DESIGN ADVISORY BOARD Tuesday, August 11, 2015 at 3:00 PM Conference Room 12, City Hall, Burlington, VT

MEMORANDUM

To: The Design Advisory Board
From: Mary O'Neil, AICP, Senior Planner
RE: 6 & 8 Proctor Place; ZP16-0020CA
Date: August 11, 2015

Request: Renovation of 6 Proctor Place, including a small rear addition and new fiberglass windows.

Site Plan

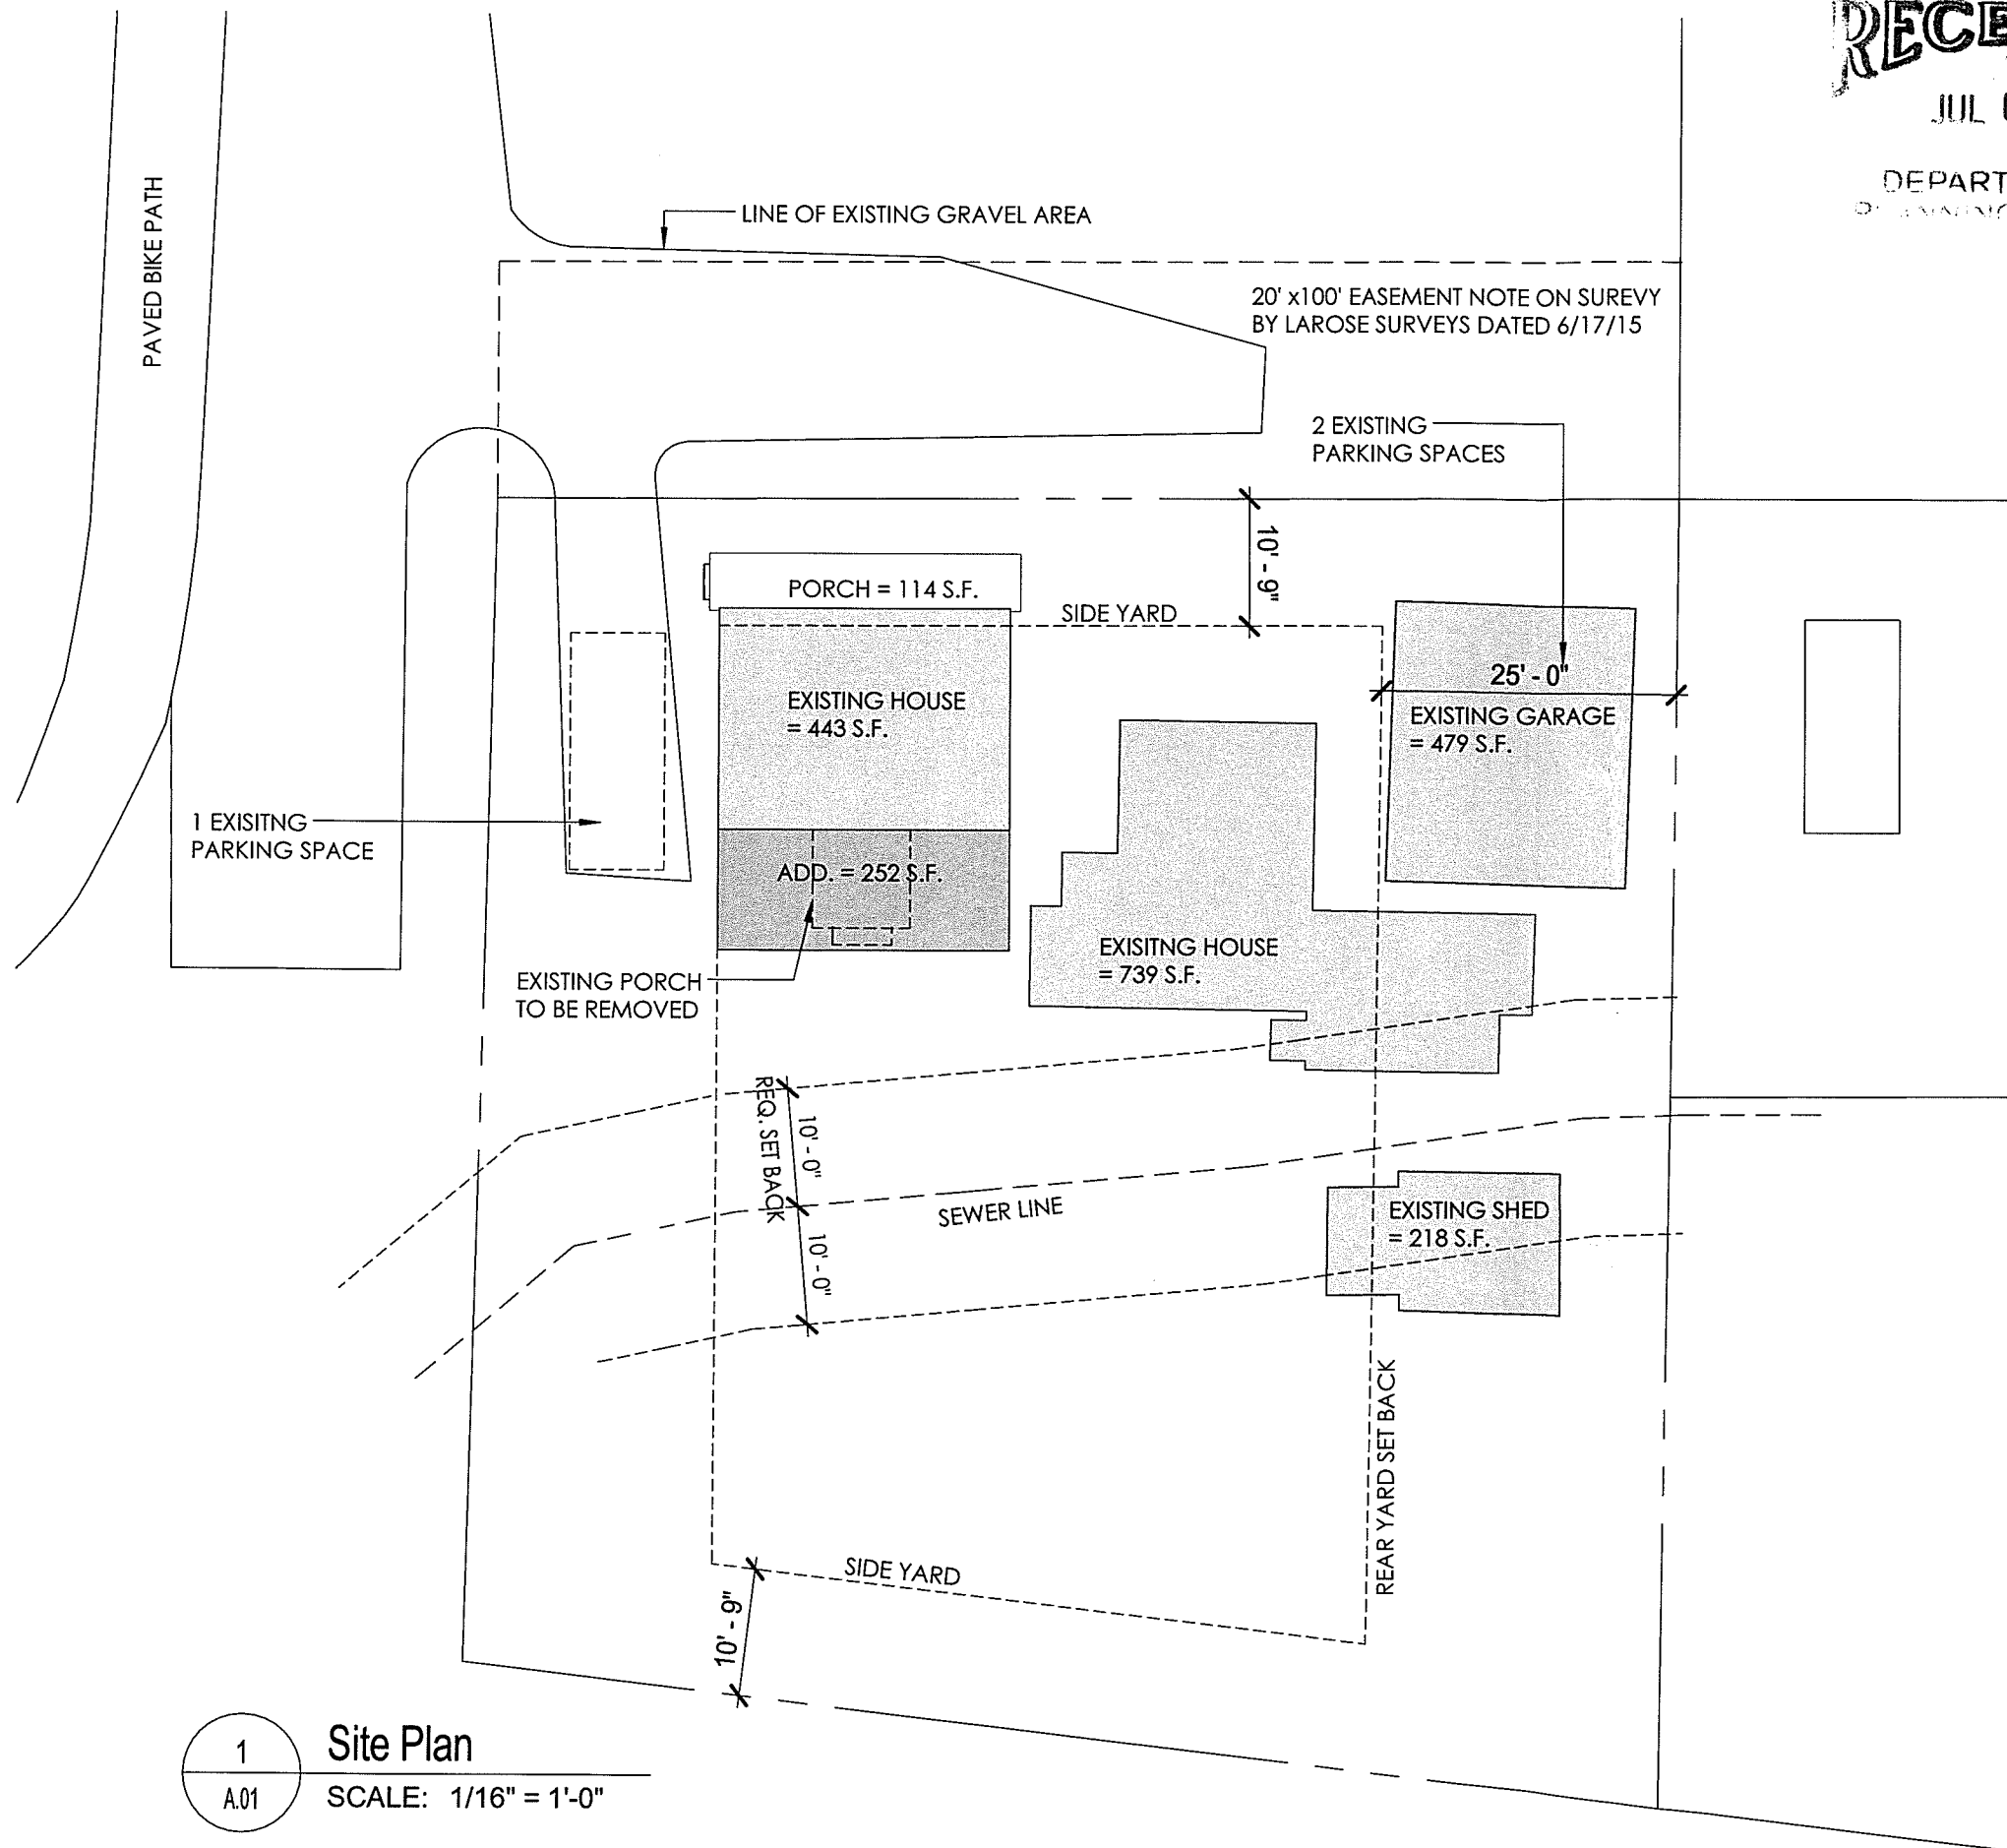
Utility connections are visible on submitted photographs, but not included on elevation or site plans. These shall be appropriately revised to include annotations to define the location of meters, HVAC equipment, utility connections, etc.

Similarly, the mailbox location needs to be defined.

The applicant shall indicate the location of trash and recycling storage.

3. The location of the mailbox, utility connections, mechanical equipment, and trash/recycling storage shall be defined on the site plan and/or building elevation as appropriate. Landscaping or similar screening may be advised, depending upon location and visibility.

4 WEST ELEVATION
SCALE: 1/4" = 1'-0"
Glazing percentage: (57.2/449.8) x100 = 12.7%

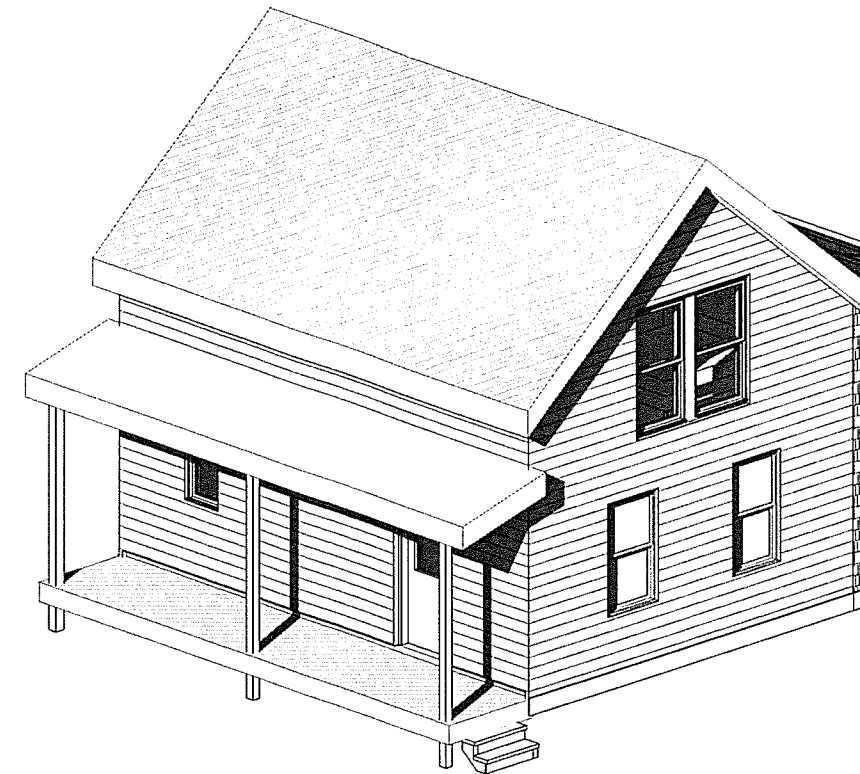
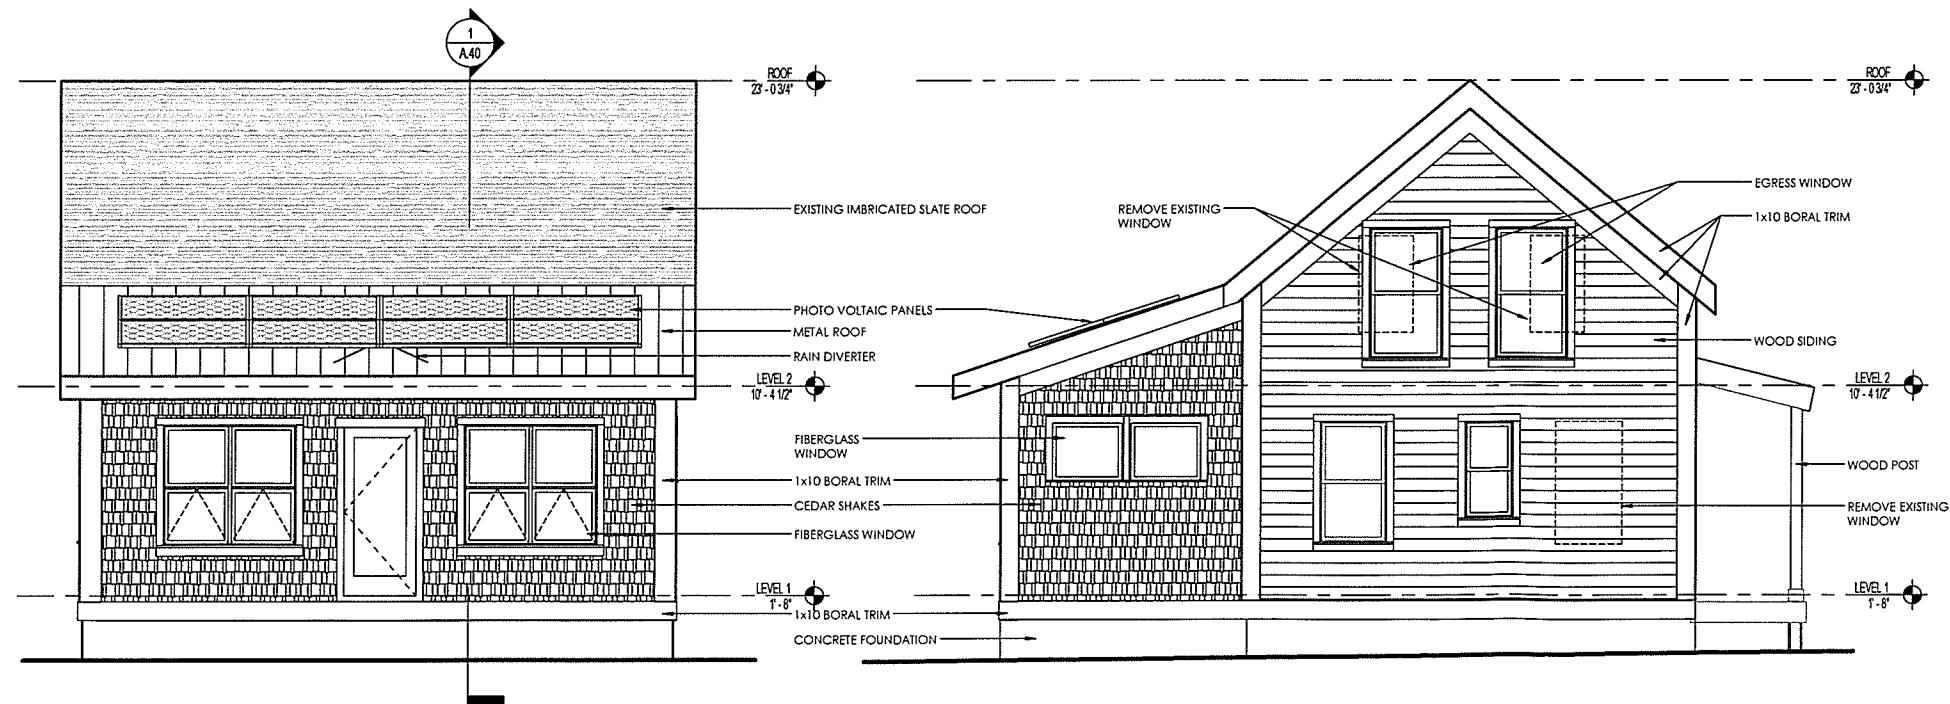
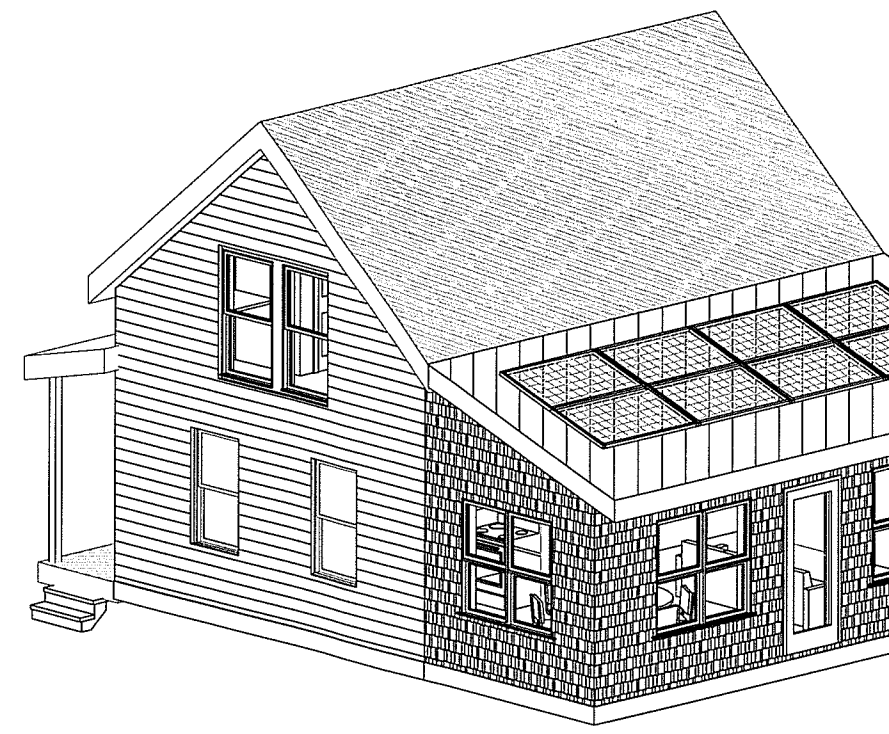
The project offers a covered front entry for refuge from inclement weather. A rear entry is not similarly protected; a small canopy or eave extension is recommended.

4. Some form of canopy or roof cover is recommended for the rear entry.
5. The applicant shall indicate the location of trash and recycling storage.
6. The judgments and interpretations made by the Development Review Board and the Vermont Superior Court, Environmental Division have set the precedent for decisions relative to window replacement on historic structures. At present, only wood or clad wood replacement sash have been found to be acceptable replacement alternatives for historic structures with wood windows. A change in policy or ordinance standard would require action by the Planning Commission and City Council.

SITE PLAN BASED ON "ROUND" 1906 MAP

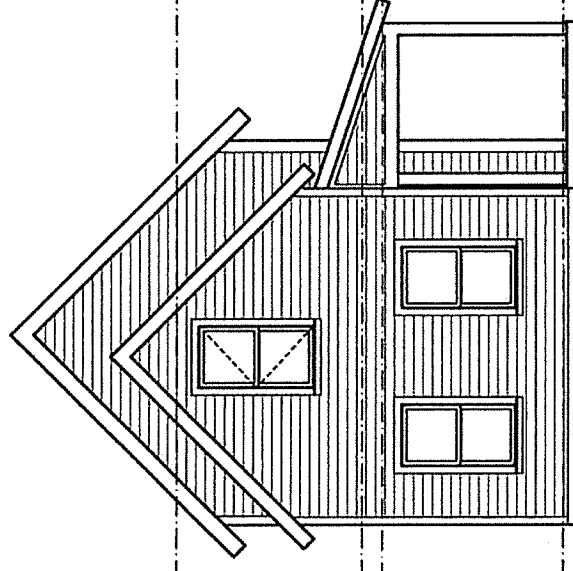
Vehicular access is proposed to remain as existing. The site plan conflicts with a previously approved site plan (ZP05-595) where the driveway access then was illustrated off the parcel, and north of the property line. This is consistent with information on a boundary line adjustment plat filed in 2005 for a neighboring property. When a discrepancy of this order is apparent, a survey is typically required to discern accurate property boundaries and to assure continued access. Additionally, that survey included with ZP05-715CA (Boundary Line Adjustment Plat for properties of Willian [sic] Lawrence Smith) notes the northerly boundary line of 83 Hyde Street as a total of 126.18 ft, not the 131 feet given on the originally submitted site plan.

No sidewalk is illustrated to the new northerly porch. Some method of pedestrian access will need to be illustrated on a site plan.

13. A pedestrian access must be illustrated from the public right-of-way to the residence. Any such walkway must be identified on a revised site plan.
14. Coverage calculations will need to be submitted prior to advancement to the DRB.
